ADDENDUM TWO

Hillcrest Commons
711 East Tillman Road
Fort Wayne, IN 46816

Commission No.: F23066

Addendum Date: 01 May 2024

6 ADA Bathroom - North
3/8" = 1'-0"

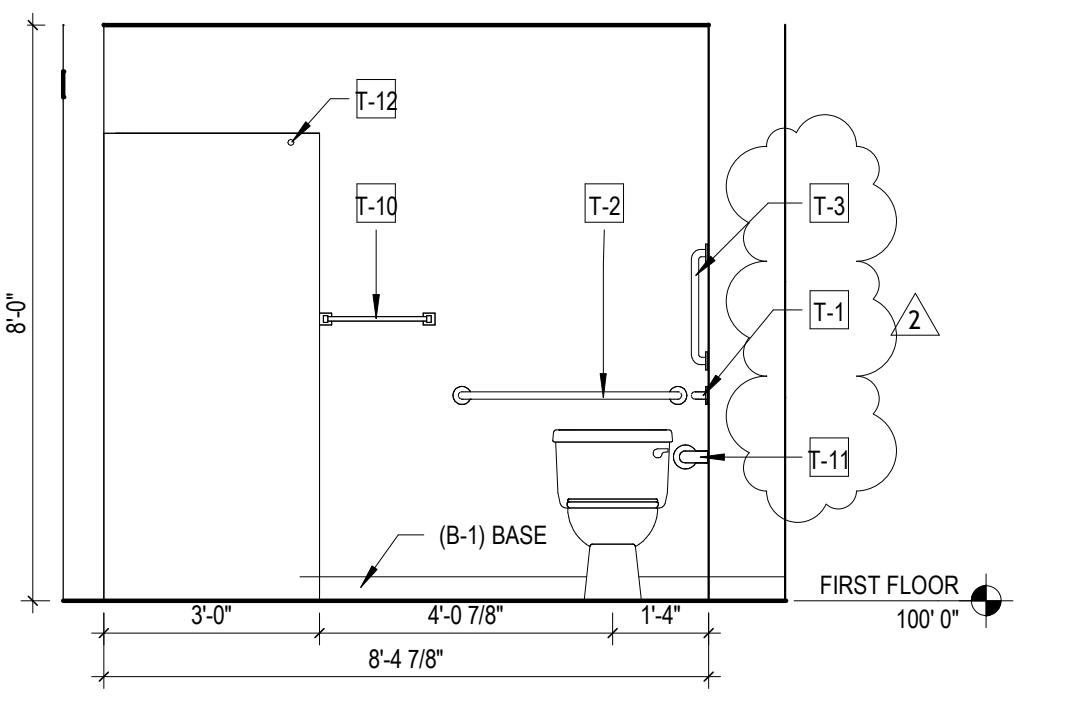
- TOILET ACCESSORY SCHEDULE:
 - **MODIFY** Toilet Accessory T-11.
 - **REMOVE** Toilet Accessory T-14, “Not in Use”.
- 2/A120: **UPDATE** (1) Toilet Accessory Tag.
- 5/A120: **UPDATE** (1) Toilet Accessory Tag.
- 6/A120:
 - **UPDATE** (1) Toilet Accessory Tag.
 - **MOVE** (2) Toilet Accessory Tags for clarity.

7 Bathroom Single Vanity
1" = 1'-0"

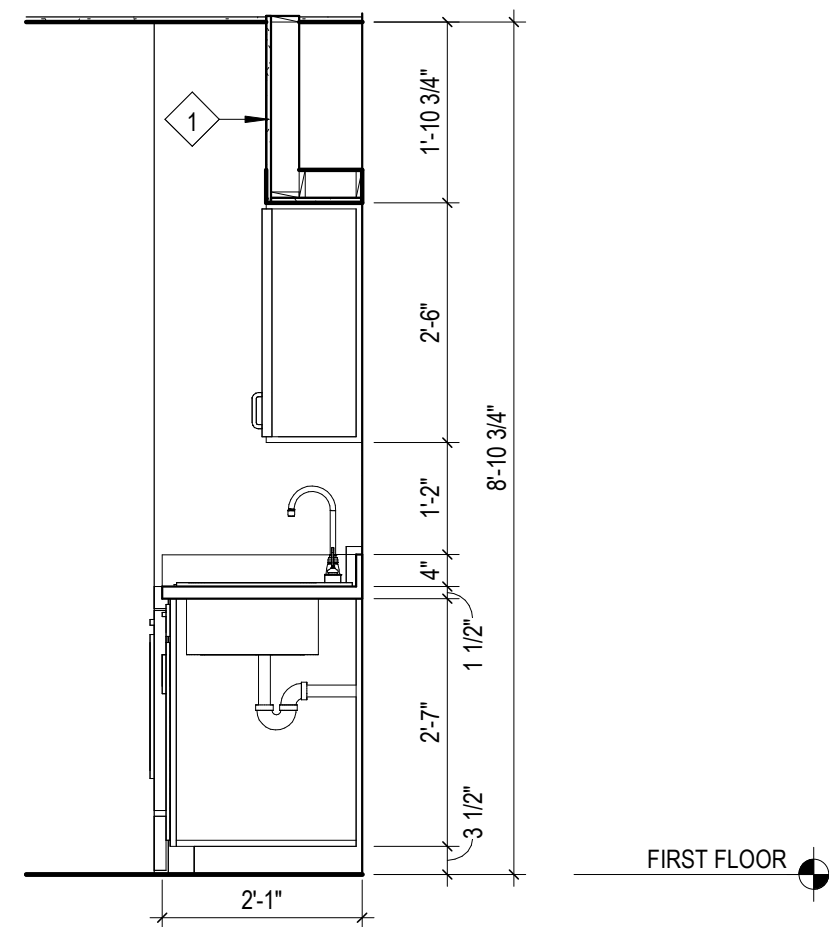
- 7/A120: **UPDATE** (1) Toilet Accessory Tag.

1 Enlarged Unit Plan A - Notes
1/4" = 1'-0"

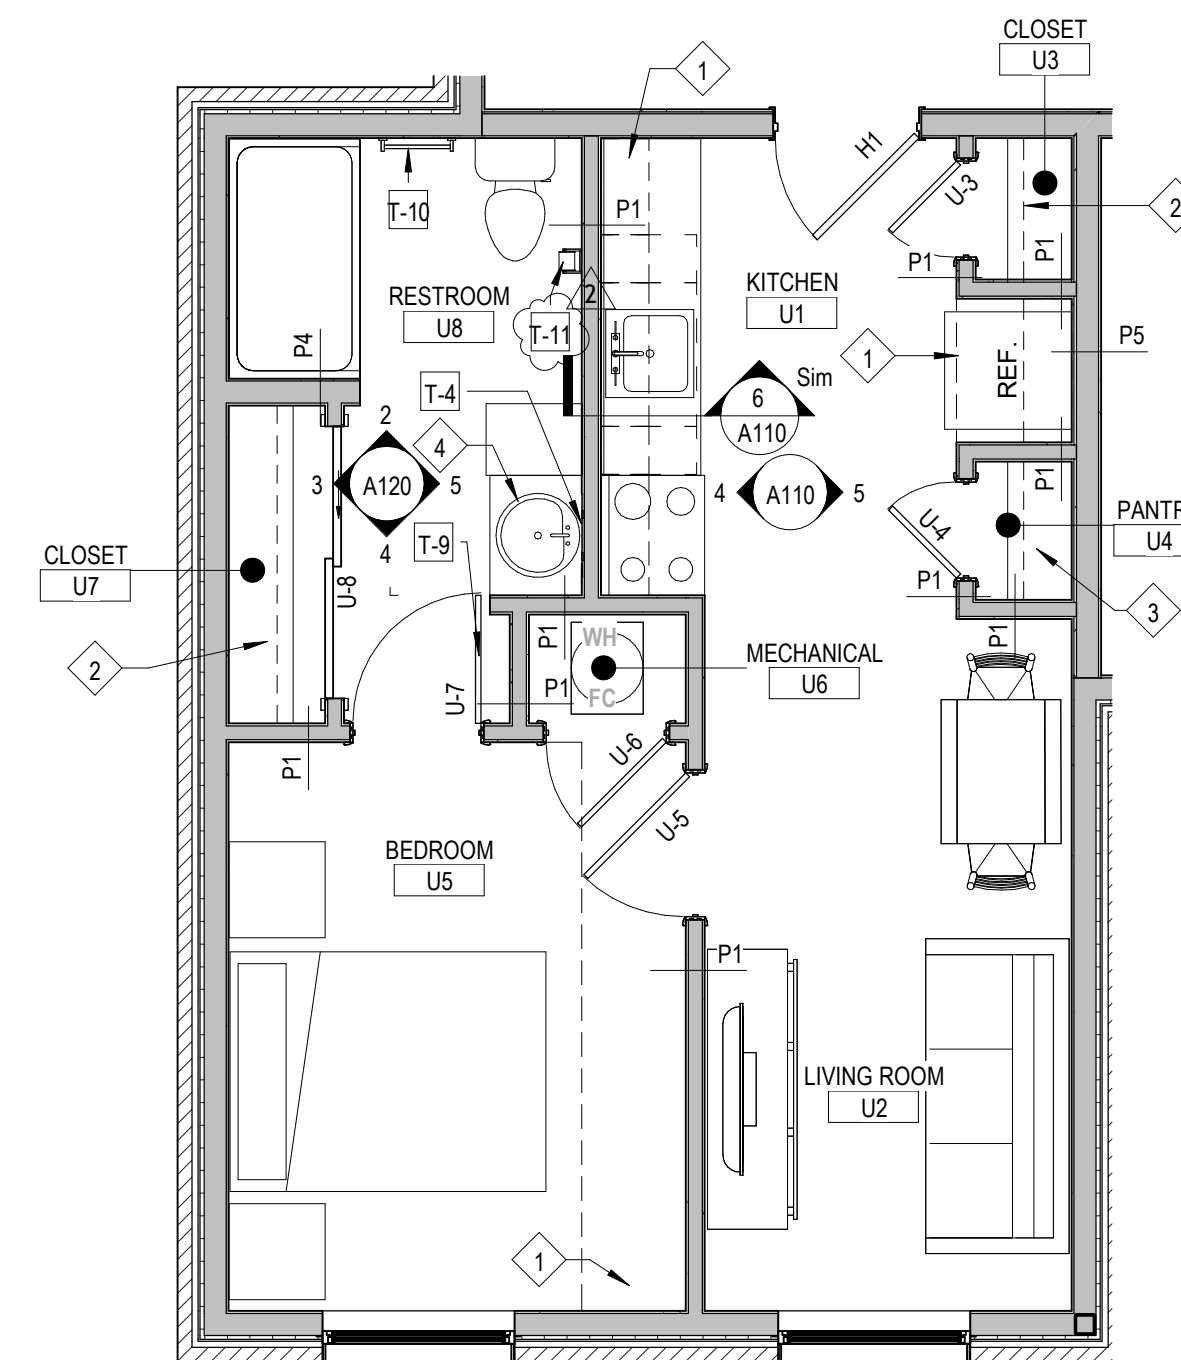
Sheet **A110** - SEE ATTACHED SHEET for revisions:

- 1/A110: **UPDATE** (1) Toilet Accessory Tag.
